AGENDA OF THE PLANNING BOARD

September 1, 2022

Re: 71 S. MESIER AVENUE
Response to Planning Board Comments

Re: 2 Delavergne Avenue
Amended Site Plan Application
Tax Grid No.: 134601-6158-10-268607

1 Proposed Site Plan
 SP1.1 Scale: 1" = 20'-0"

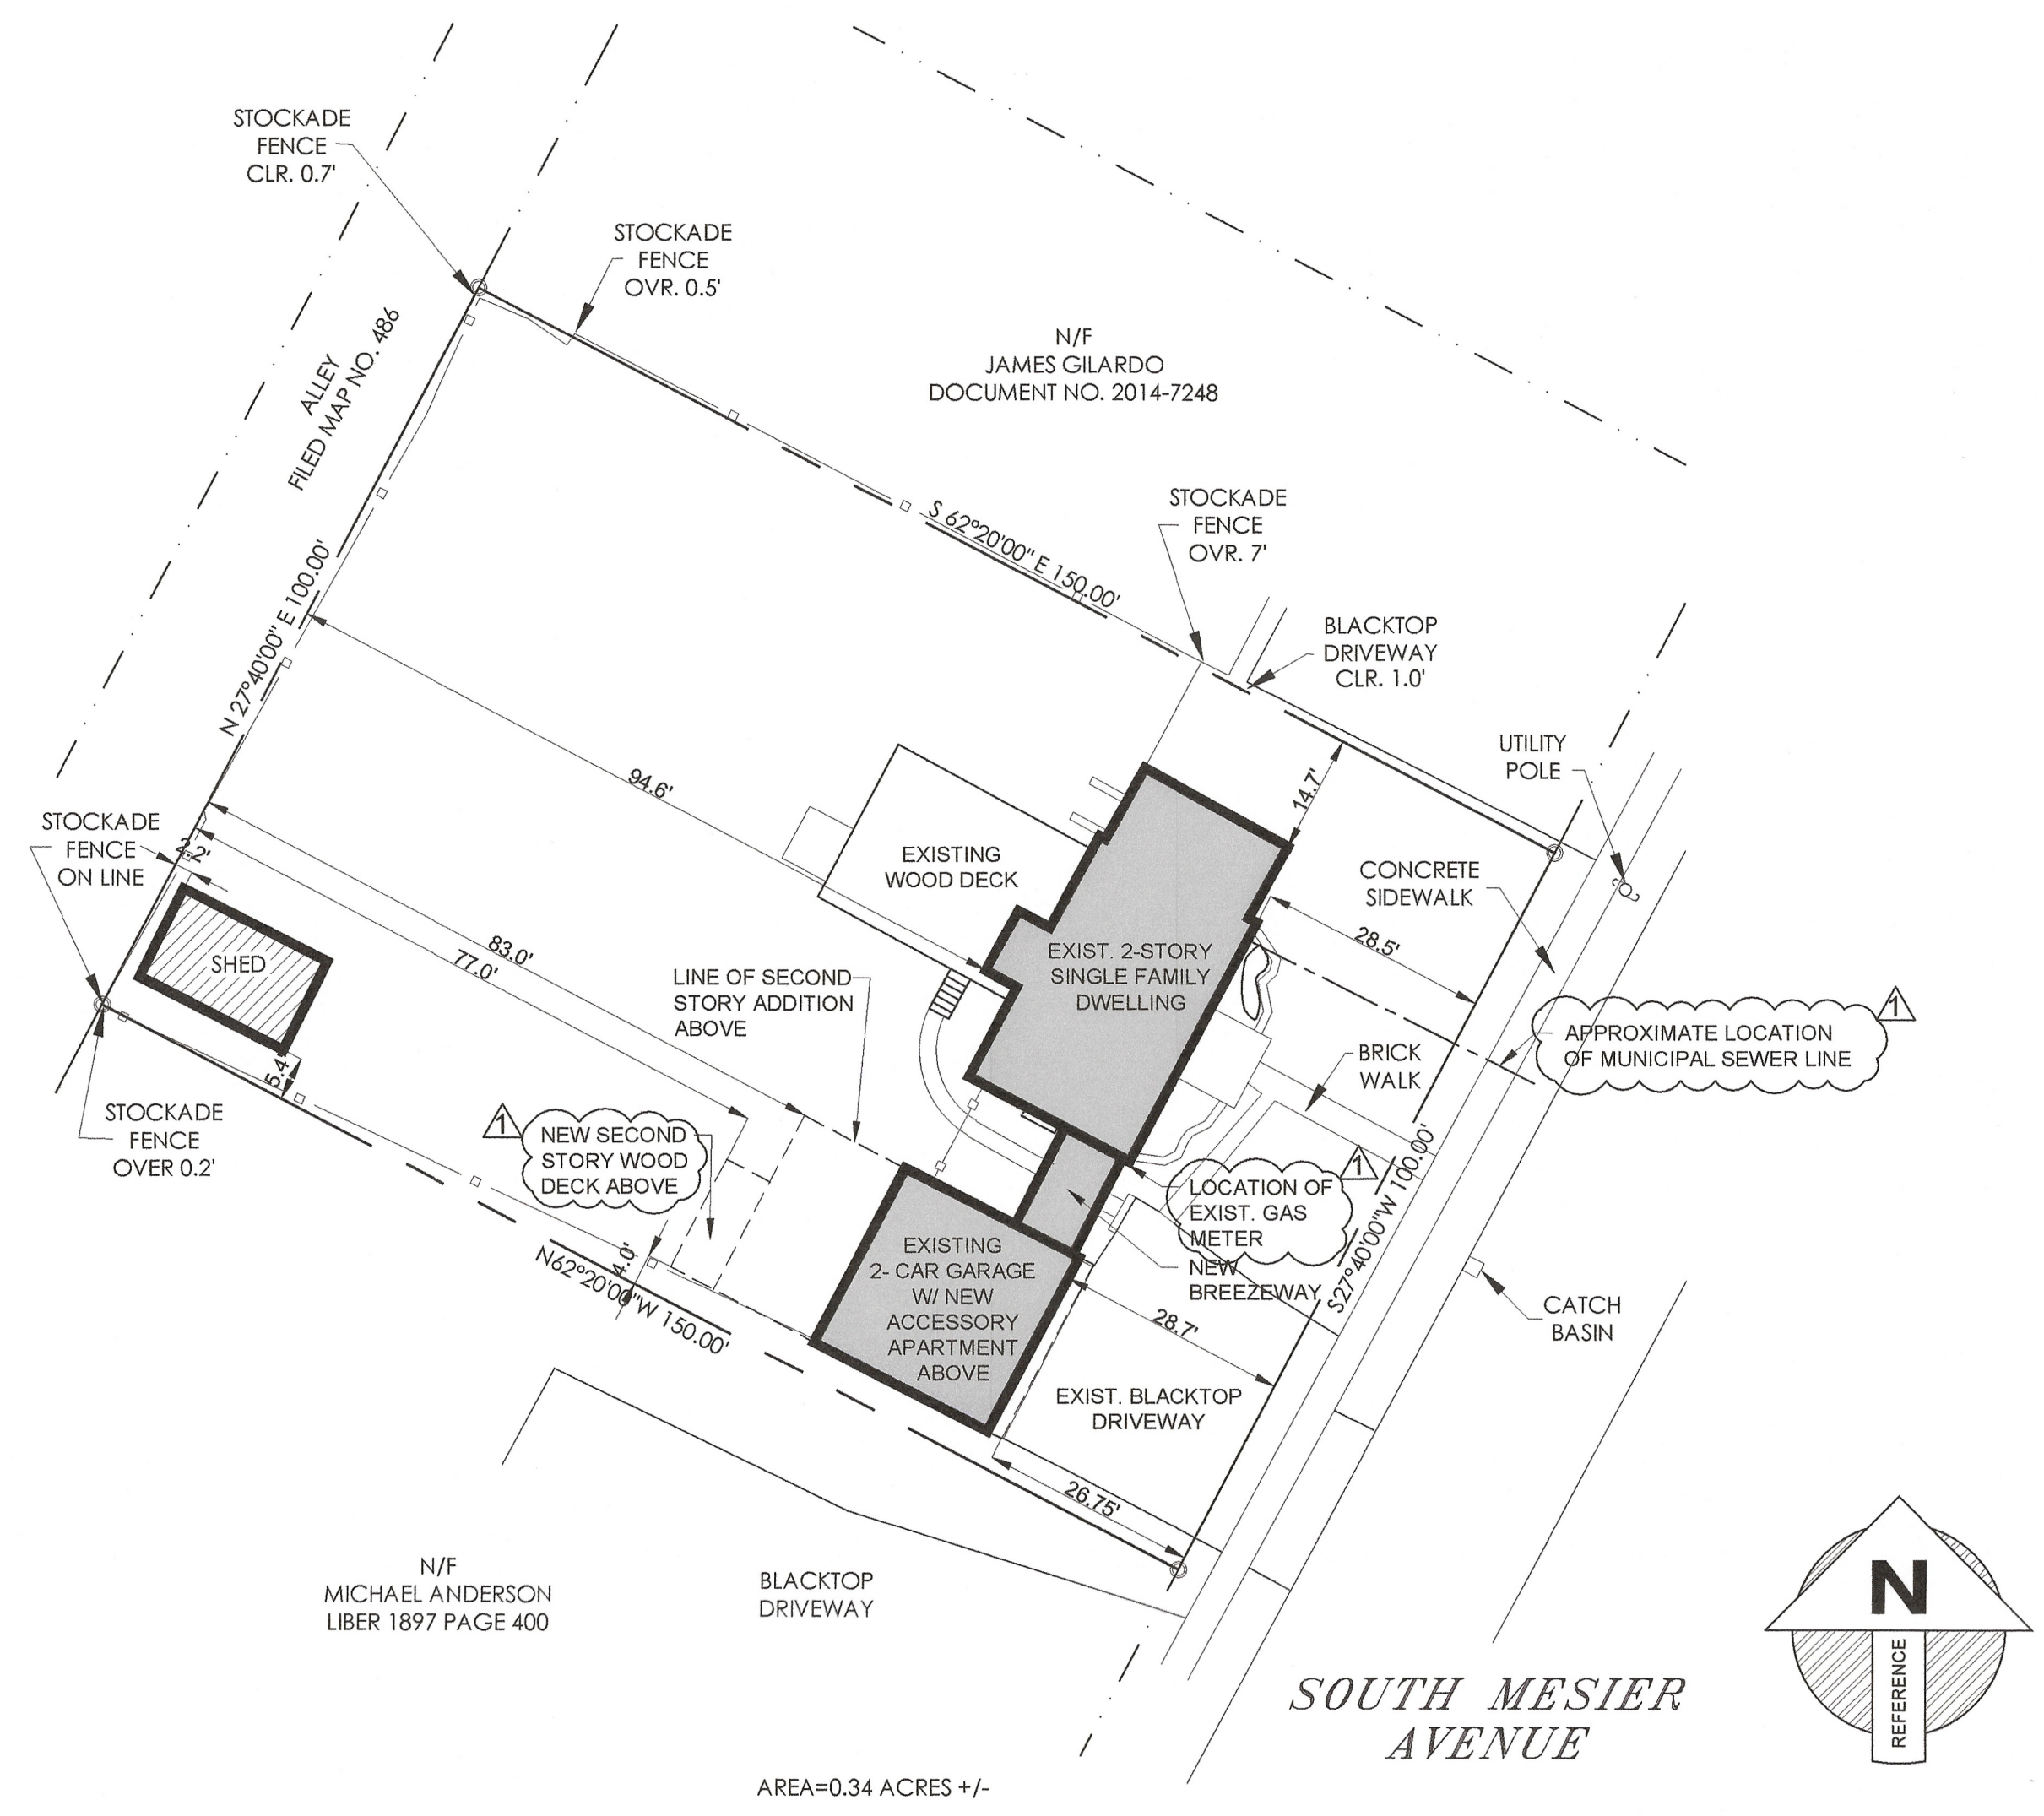
1. The bulk table of requirements on sheet SP1.1 indicated an accessory dwelling is permitted by right. A special permit will be required for the proposed actions.
The Bulk Table Requirements in the Zoning information has been revised to state: "Special Use Permit and Site Plan Approval"

AMENDED SITE PLAN

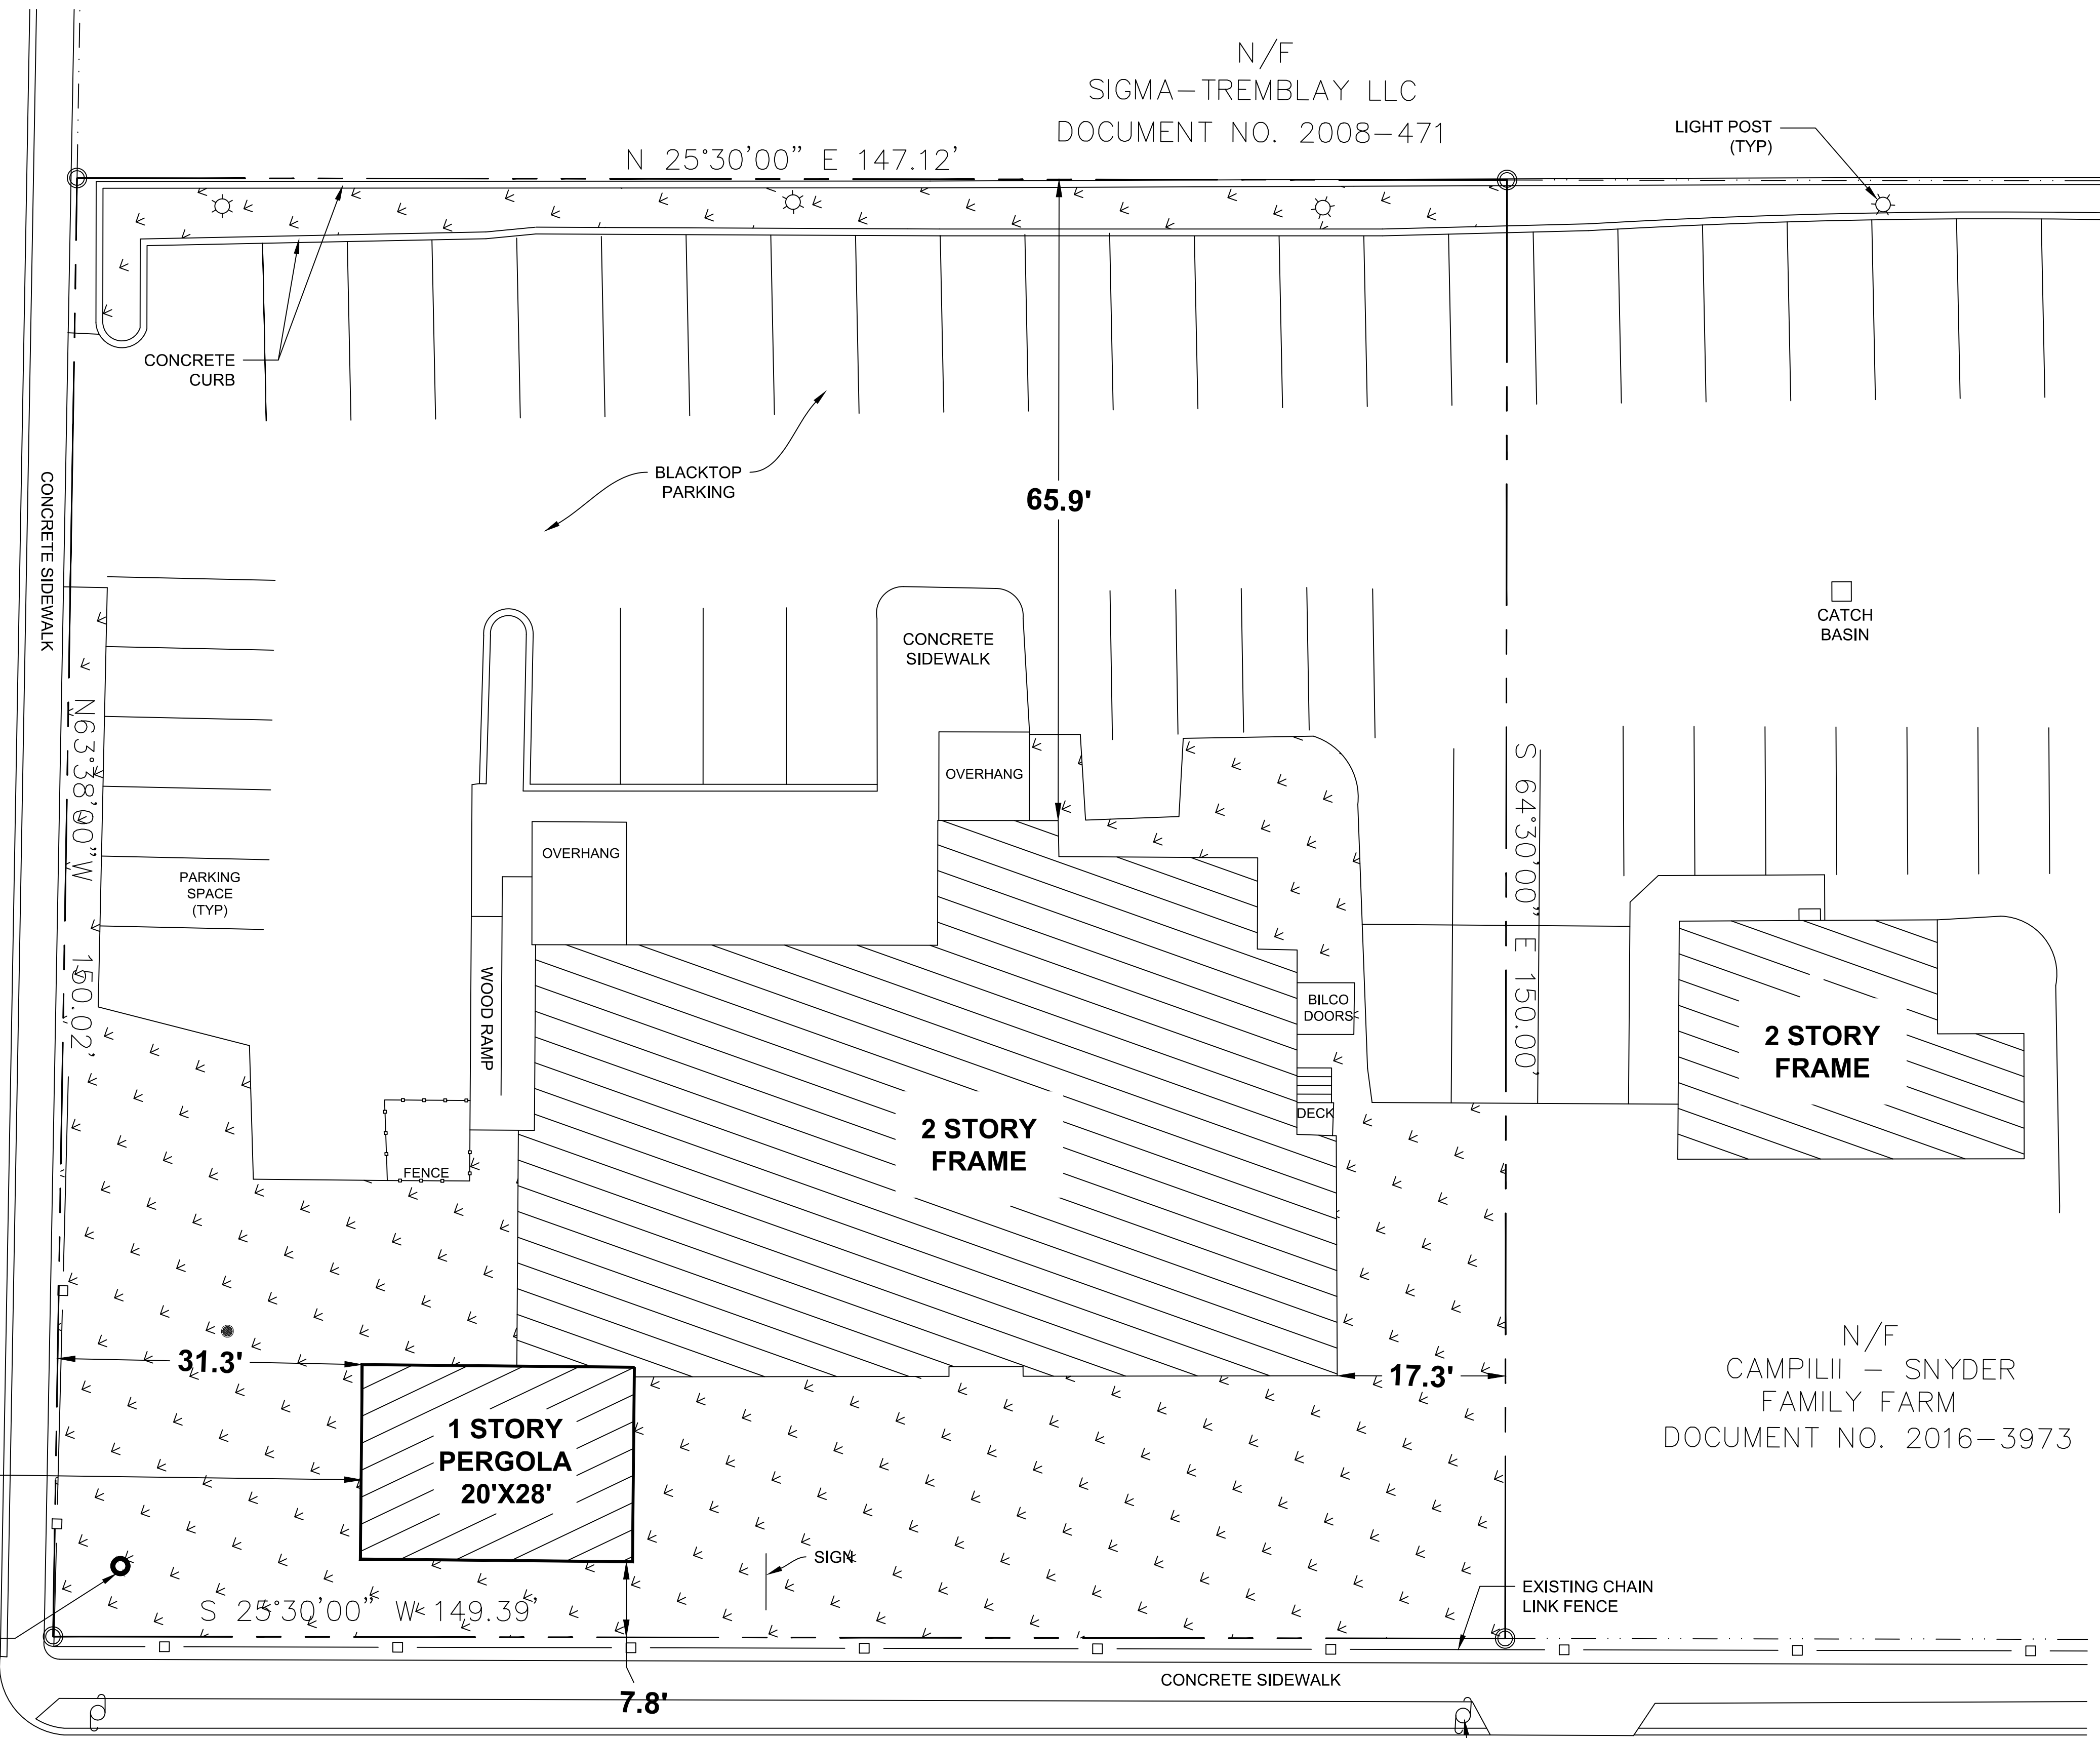
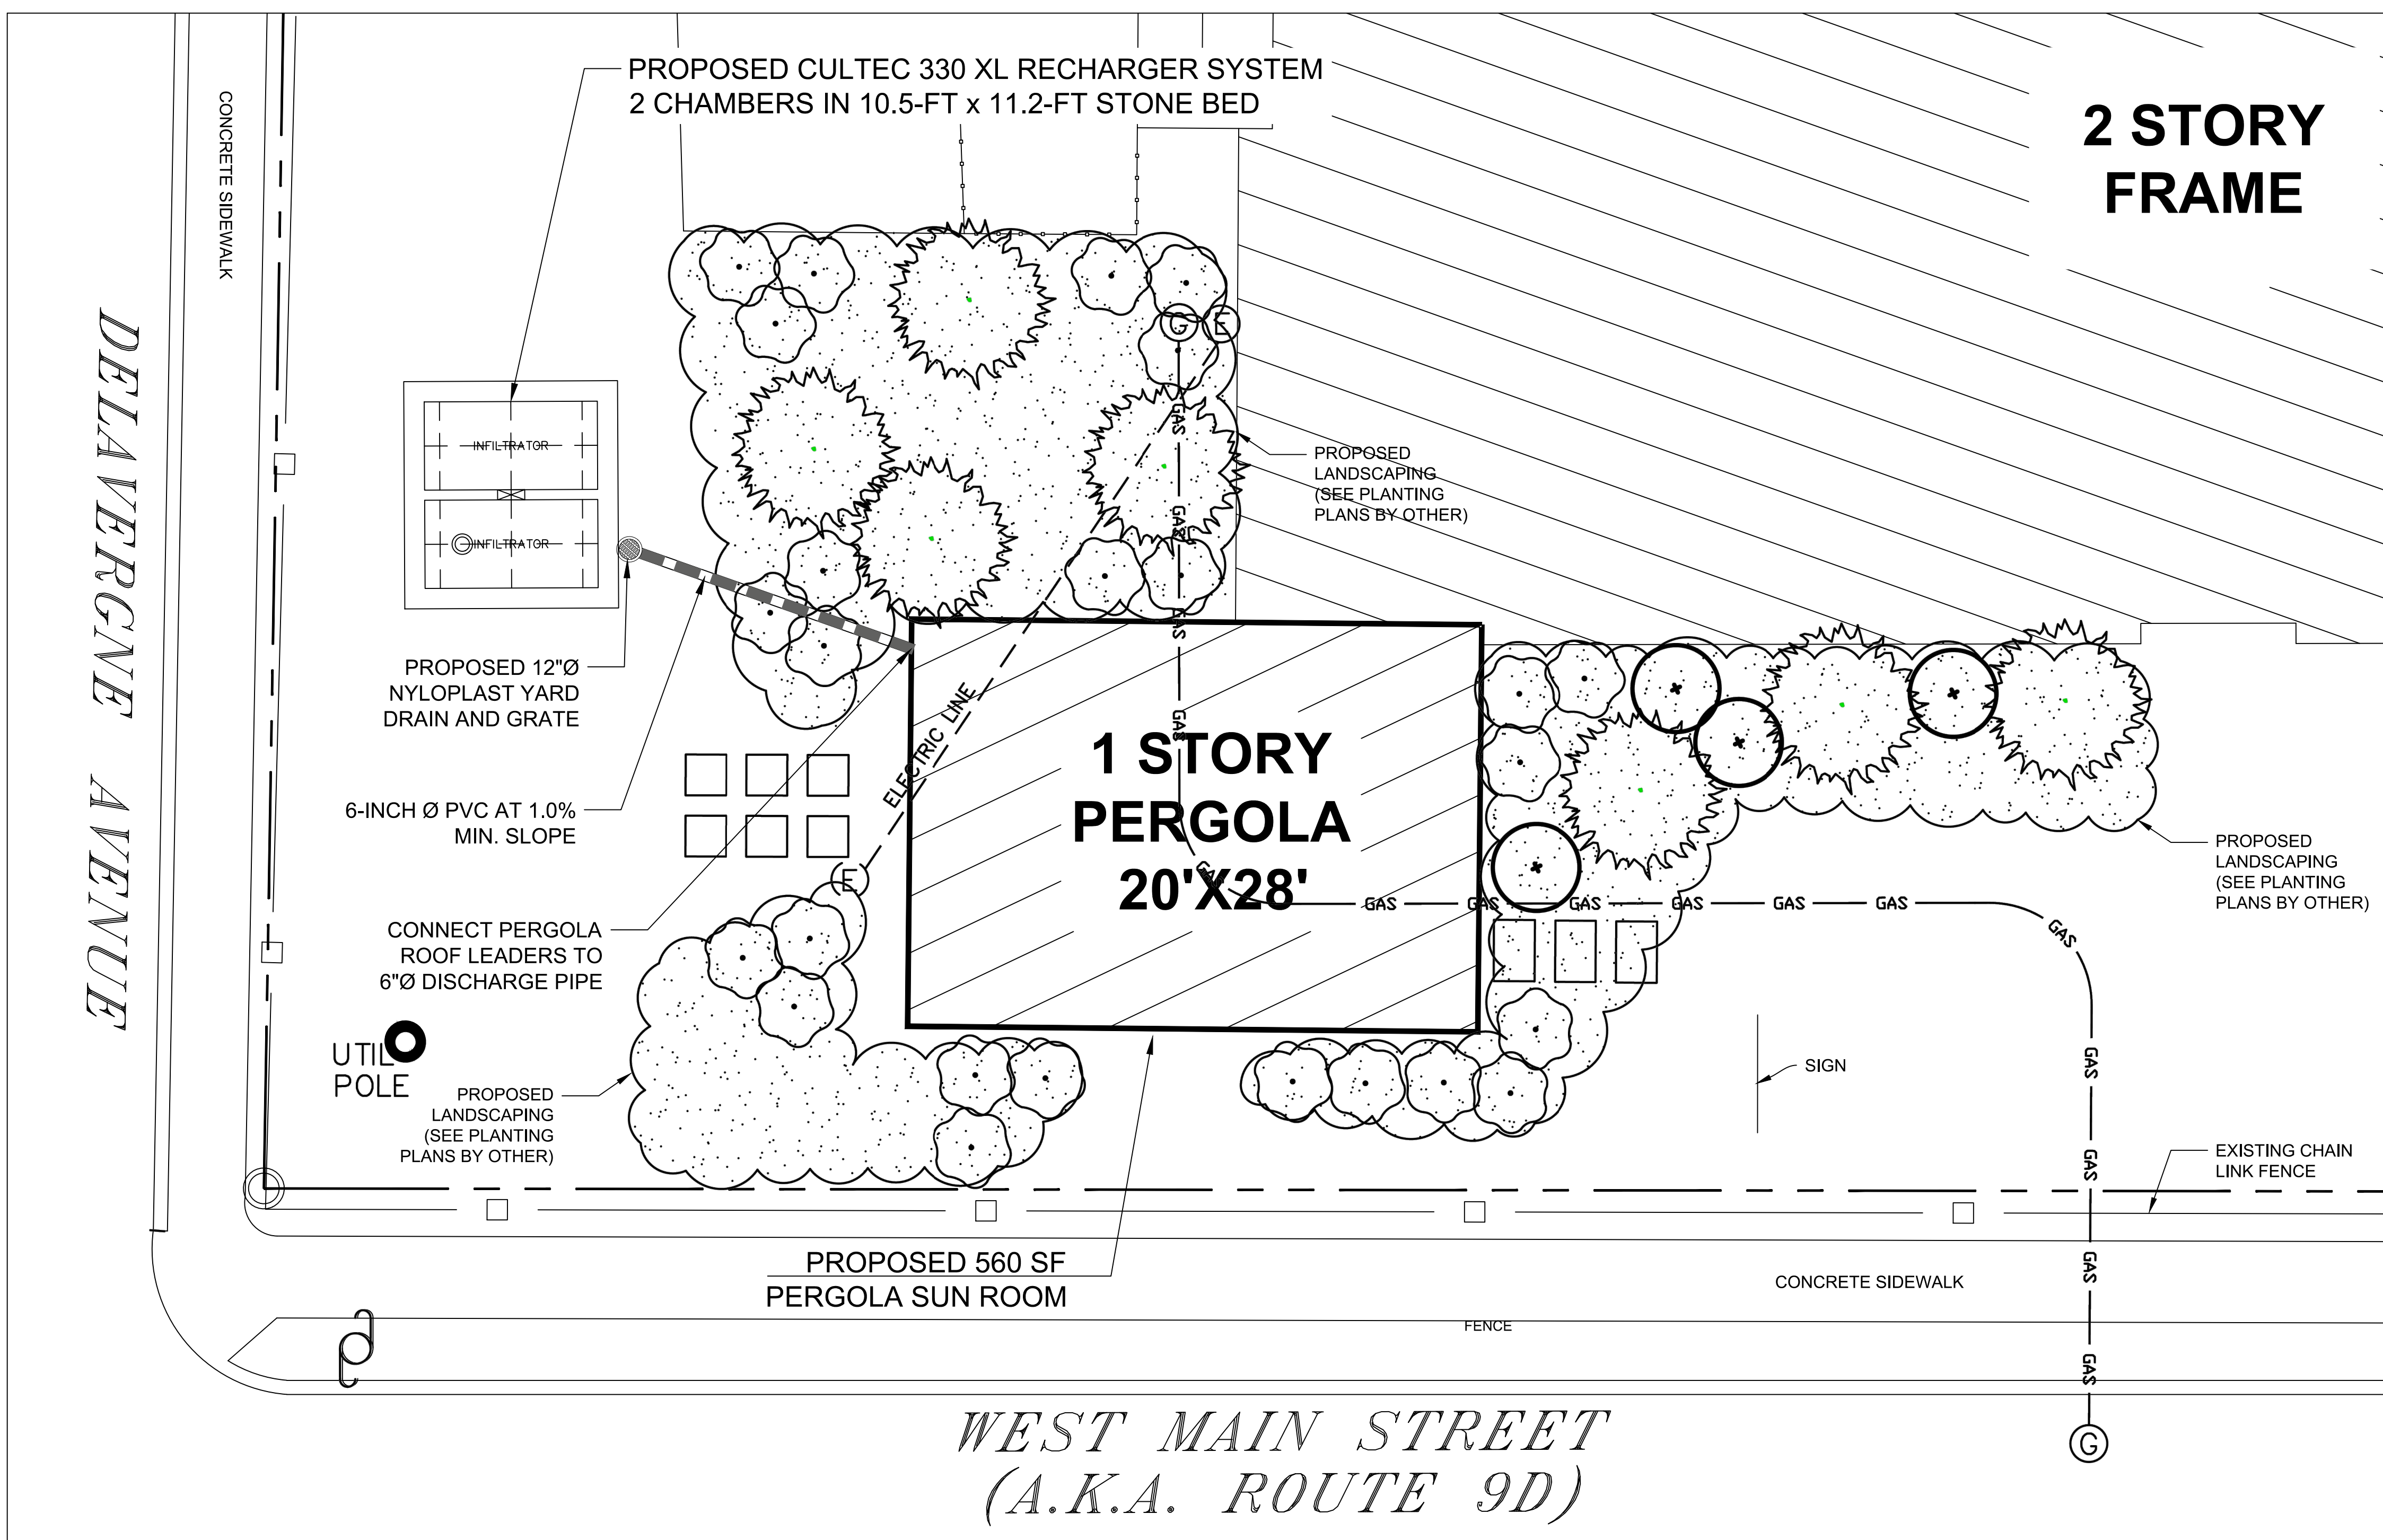
6. *Comment: Can the sunroom be relocated to the Delavergne Avenue side of the building to eliminate the need for a front setback variance?*

Response: The Owner has evaluated relocating the proposed sunroom as suggested, however, the location of existing treatment rooms and the need to maintain current ADA compliant circulation throughout the treatment areas does not allow for this.
